WORK REPORT

A/C REG	: N/A
PN	: 709-0160-48-101
SN	: P1532
Description	: A109 TR BLADE
TSN	: 957.32 hrs

LM/21/01

DESCRIPTION :	Tail Rotor Blade	RO NO :	AWM-21-081
PART NO :	709-0160-48-101	CUSTOMER :	Galaxy
SERIAL NO :	P1532	AIRCRAFT REG :	N/A

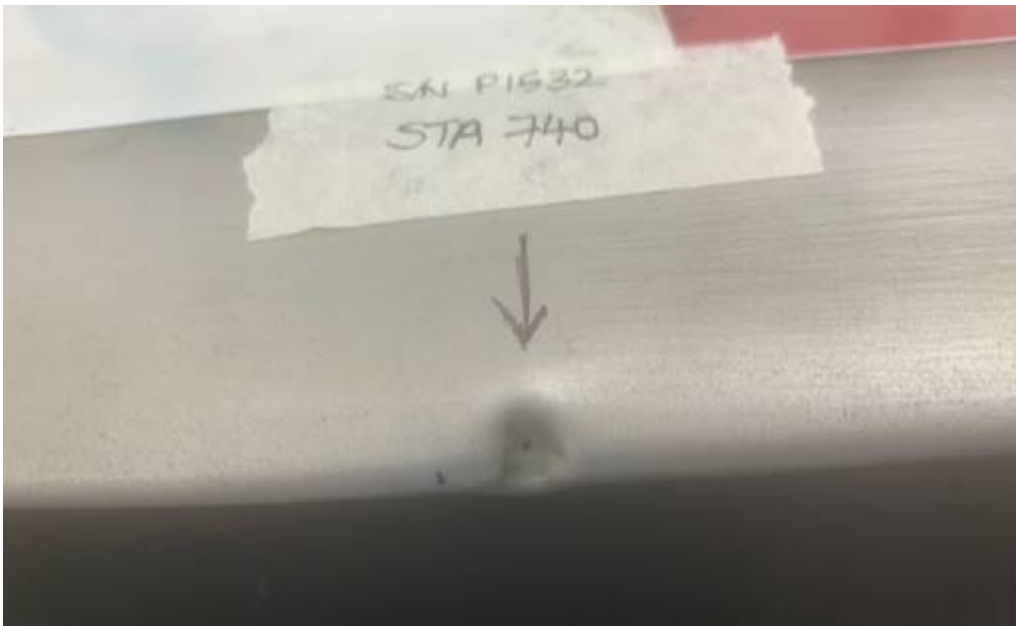
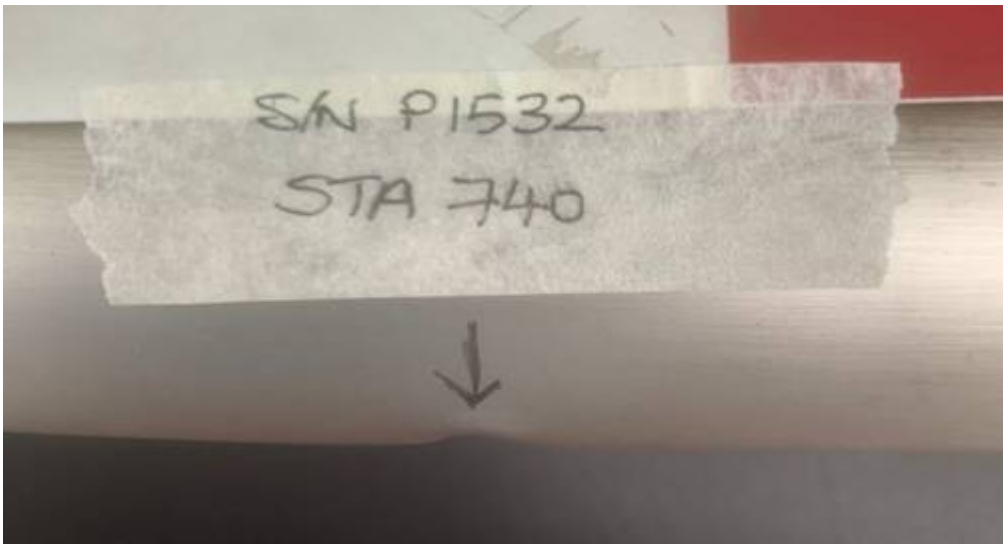
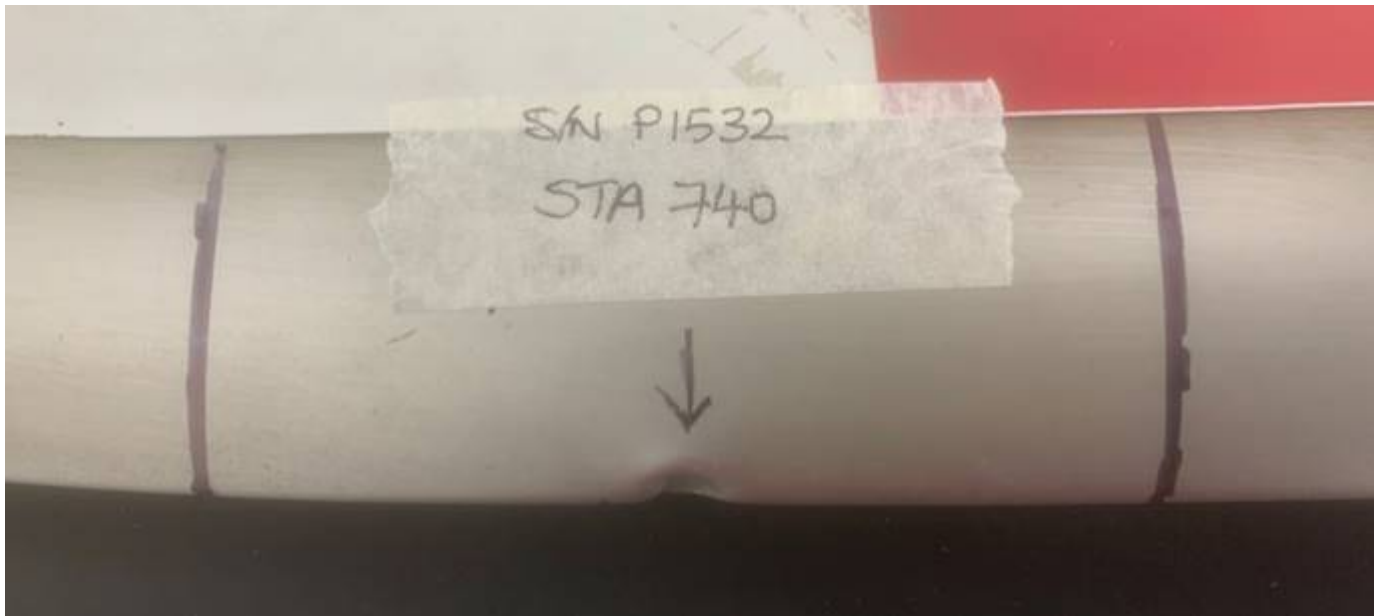
We received the subject TRB and found a sharp dent on the leading edge of the erosion shield @ STA 740 (see photos below). The depth of the dent is 2.87mm.

With reference to the A109S IETP DM 3C-A-64-11-01-00A-280A-C Step 10.2, sharp dents on the erosion shield are not permitted. We plan to trim and remove the marked area of the erosion shield as shown below to inspect whether the spar has been damaged as we believe that the blade can be sent back to Italy for an erosion shield replacement if the spar has not been damaged. Please advise if you have information to the contrary which would mean that our time is not wasted.

- Blade to be scrapped as per PSE-TQ-2021-39666

With respect to this case, the blade cannot be repaired nor erosion shield replacement can be performed. Therefore, the blade needs to be scrapped.
